ANADROMOUS WATERS CATALOG/ATLAS
CORRECTION FORM

Map: Charley River B-2,B-3

Water Body Number: 334-45-11000-2354

Anadromous Waters Catalog Number of Waterway 334-45-11000 (YUKON RIVER) - 2354

Charley River B-2

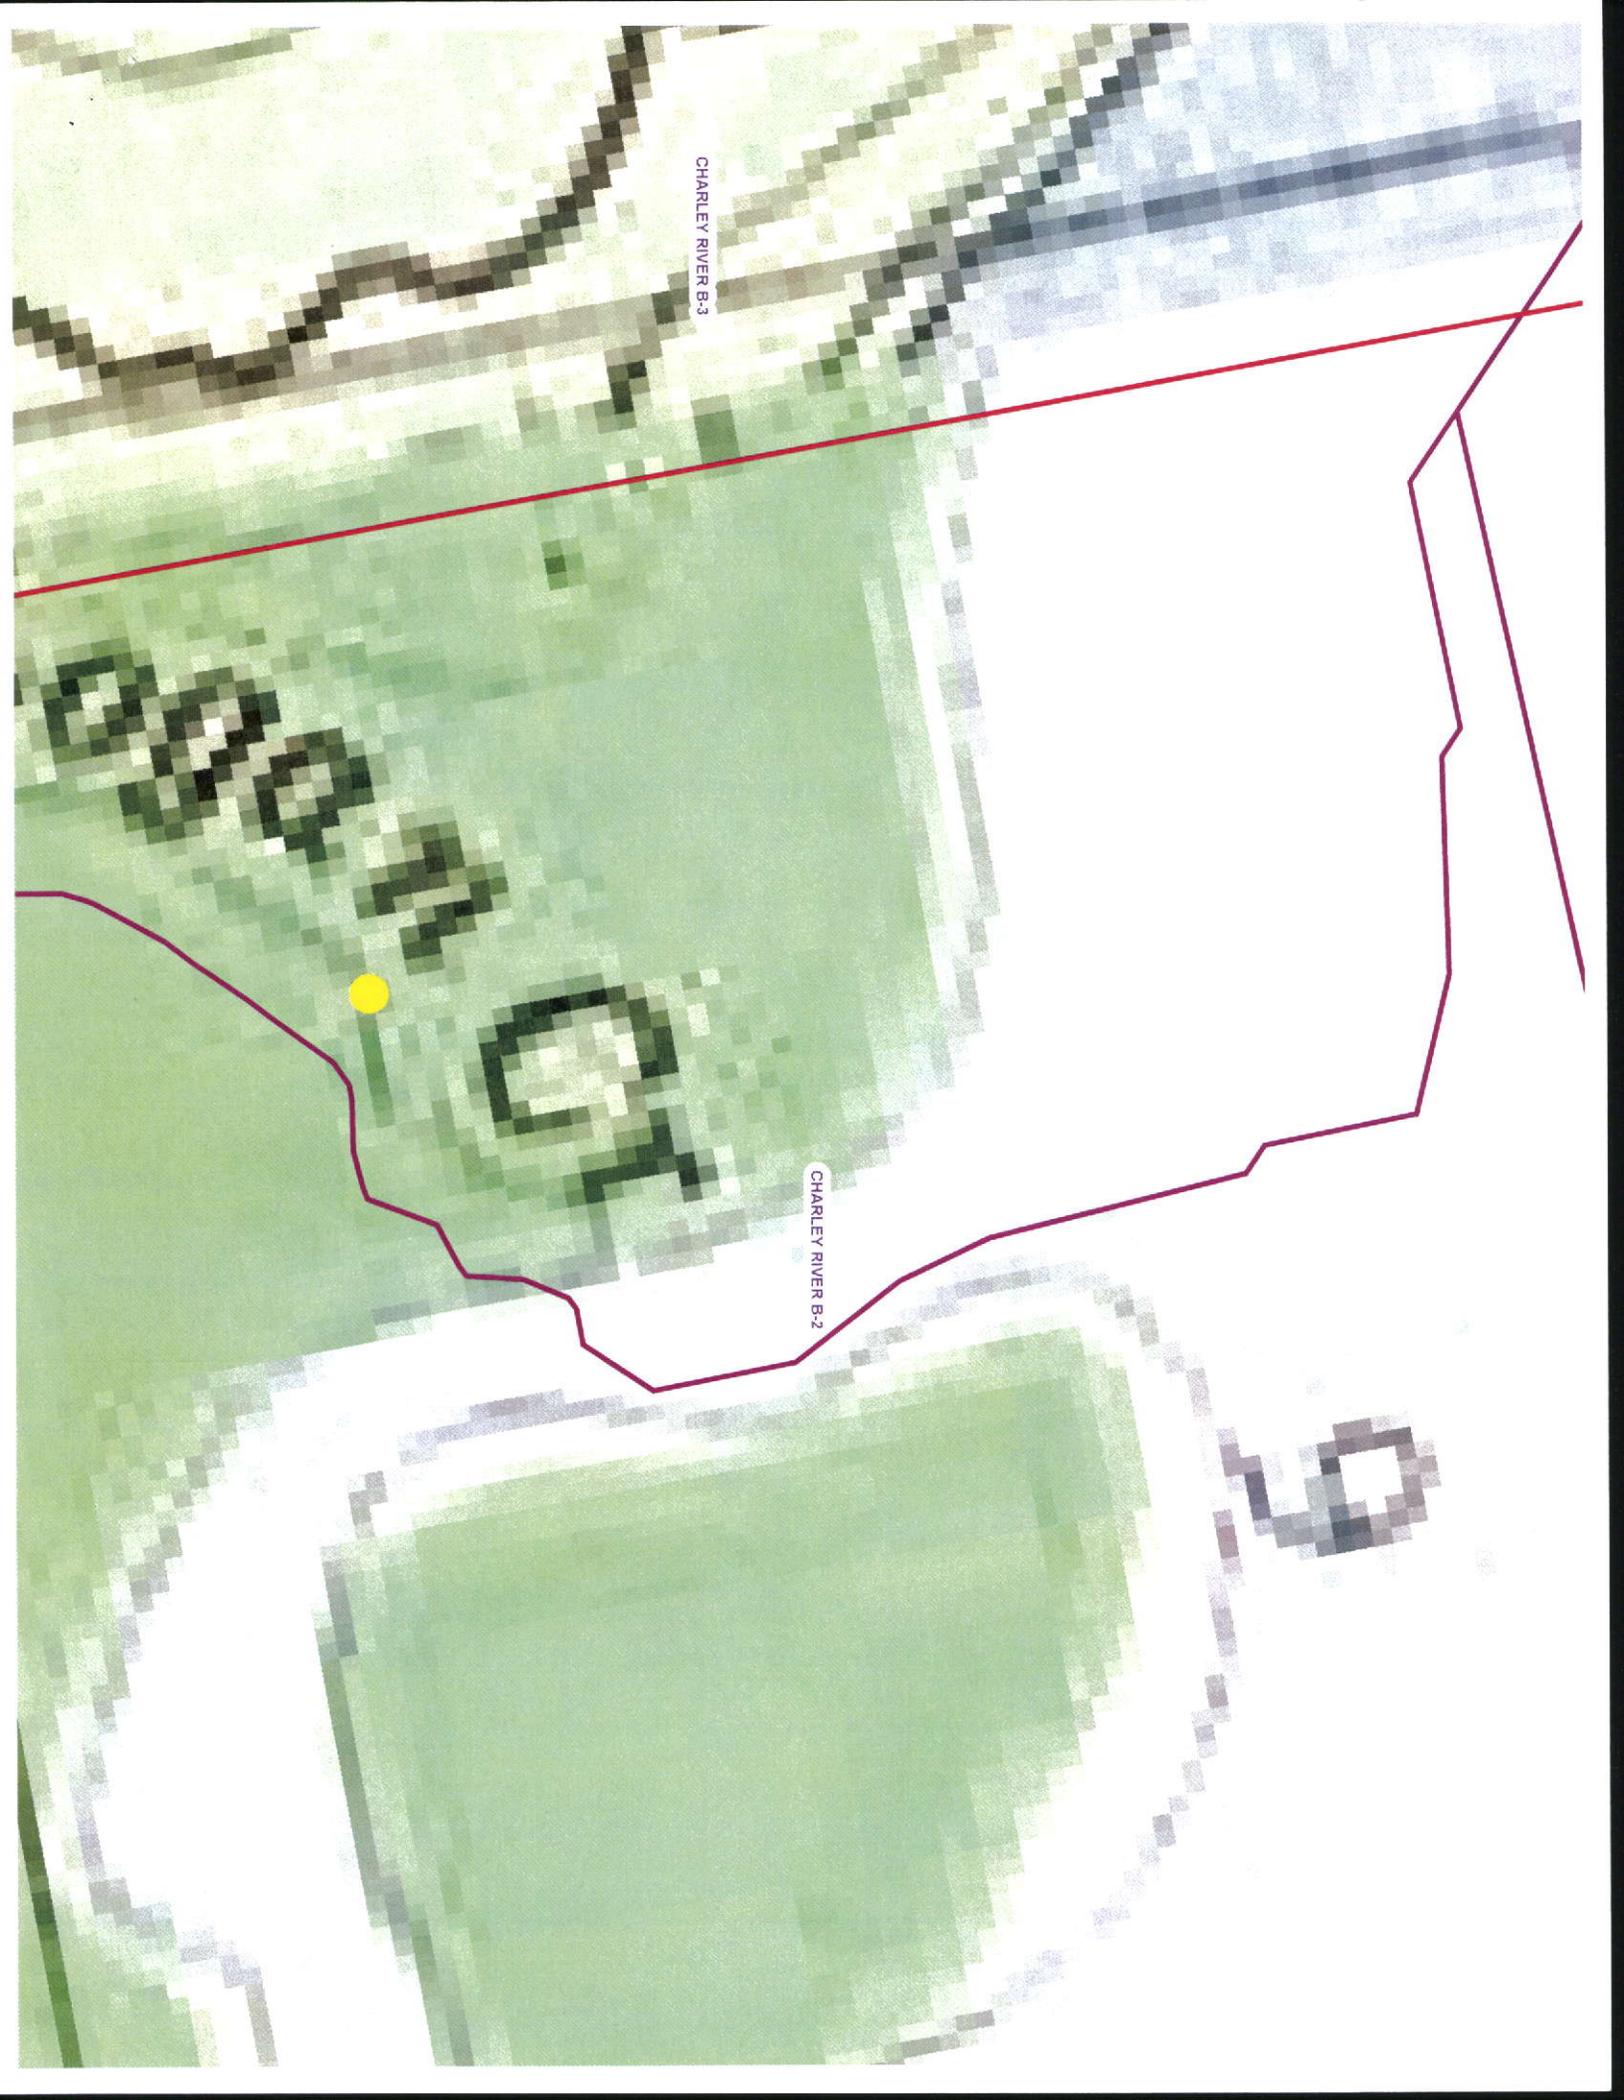
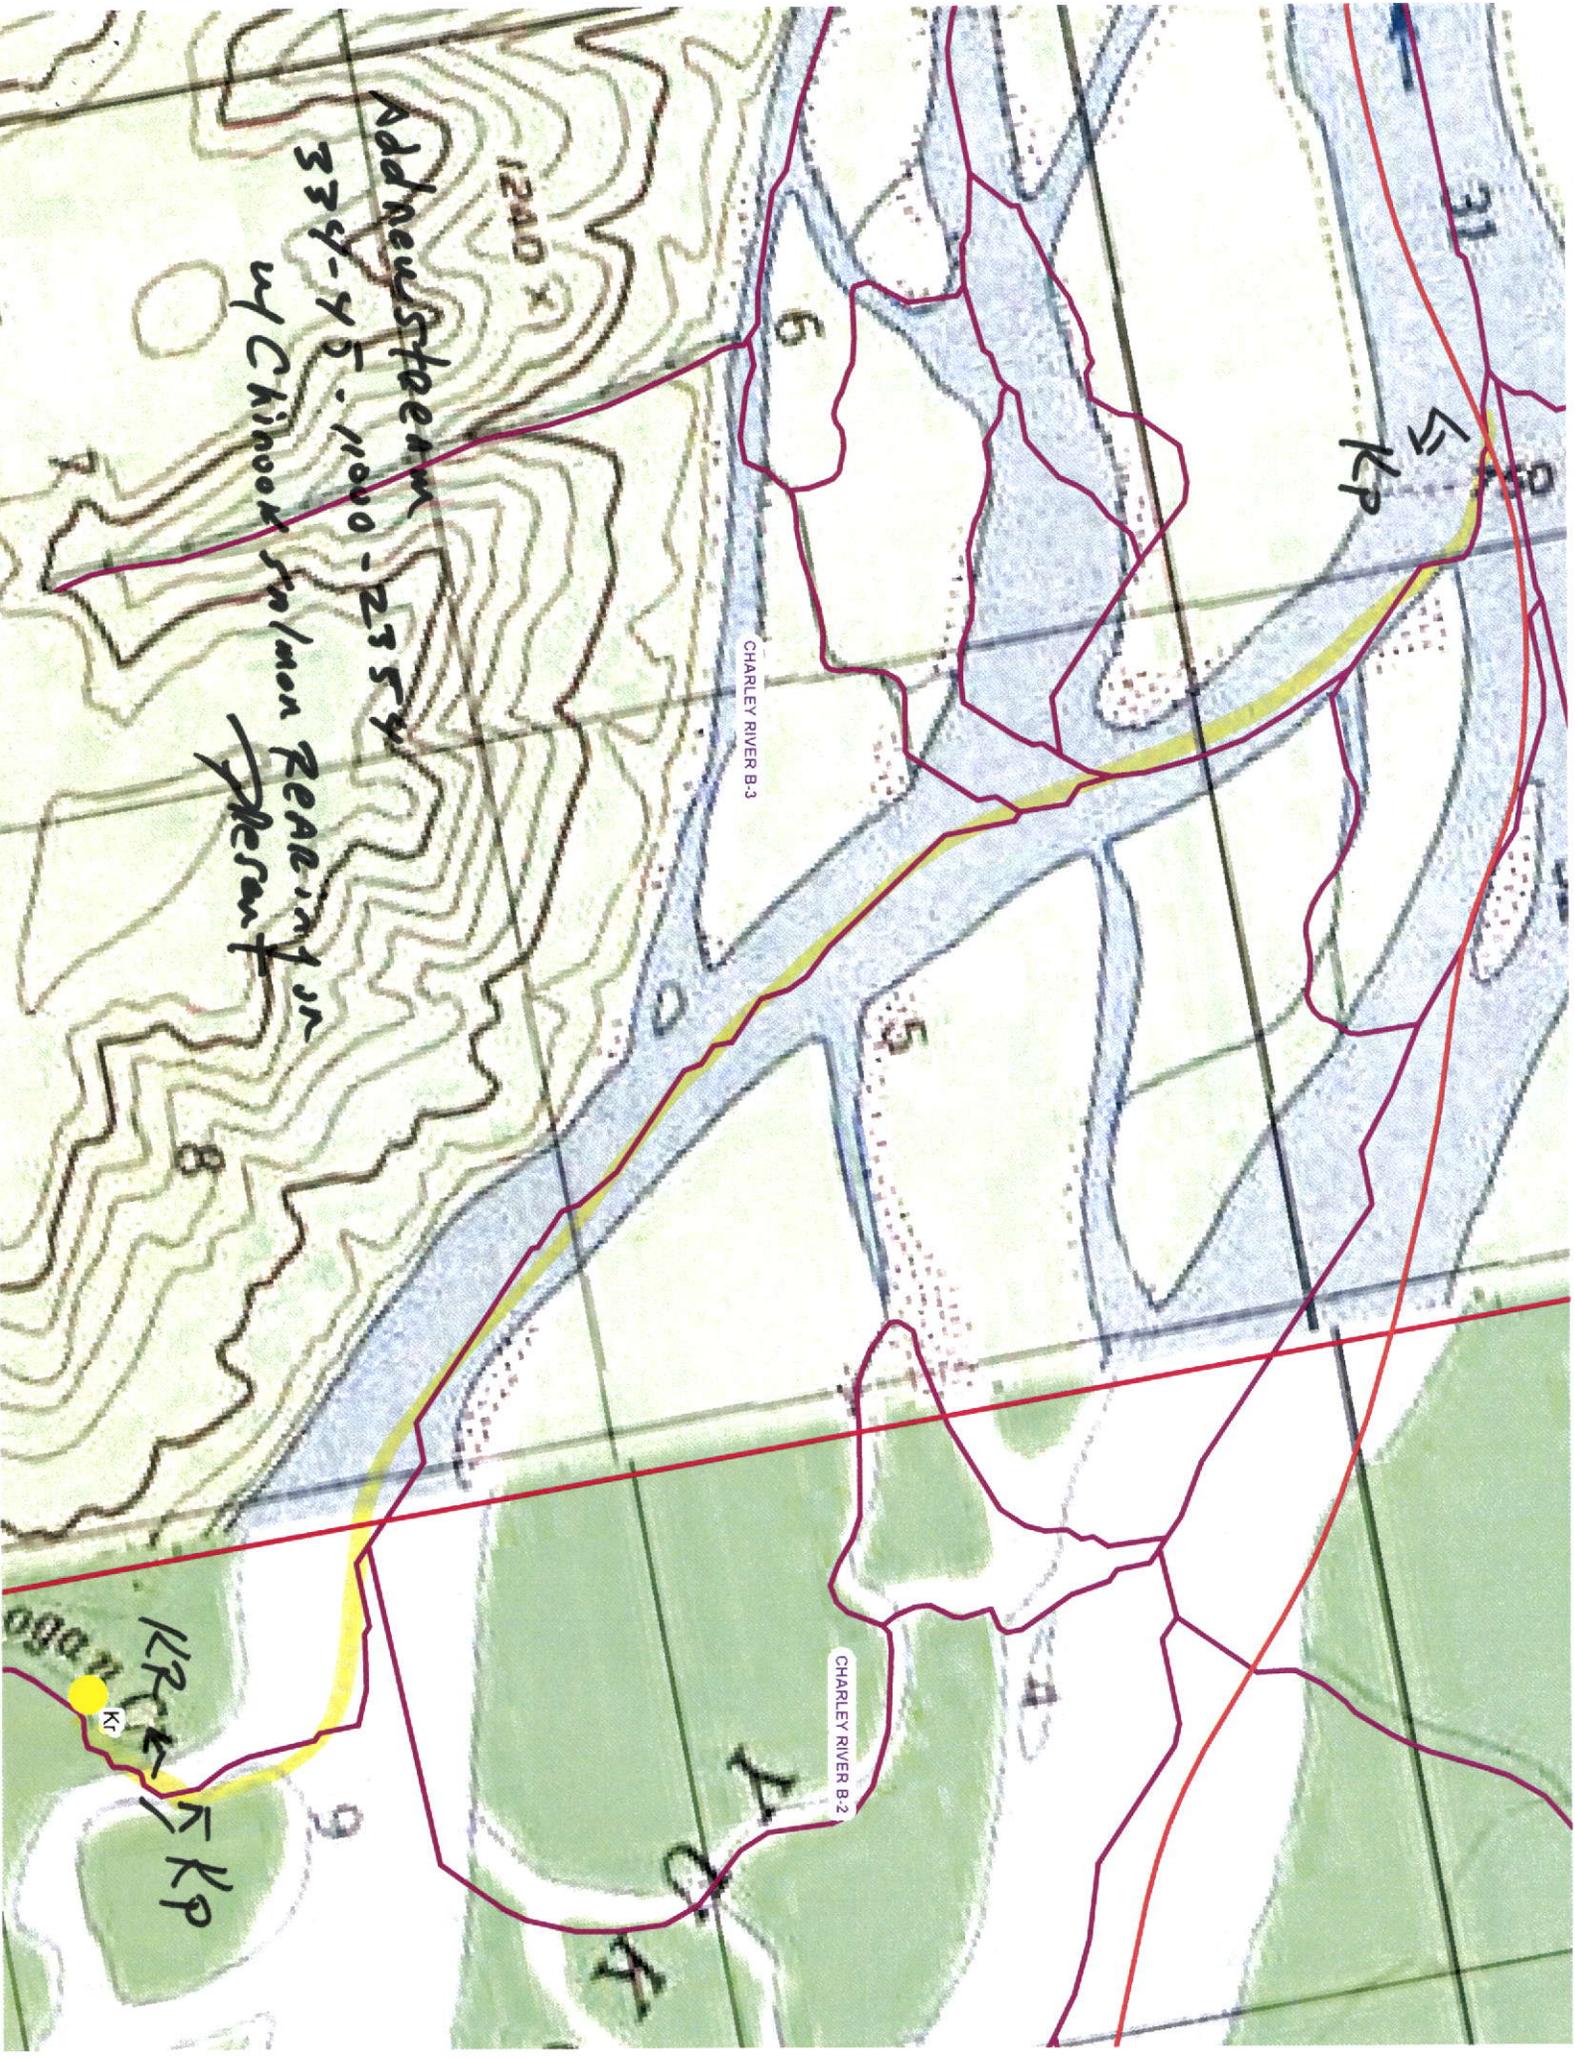
KP

KP
K
KP

Nomination #: 09-165. Logan Creek Should have Kr and not Kp or Krp on both maps.

Describe Change(s): Changed Kp to Kr.

*Change KP to Kr
For 334-45-11000-
2354*
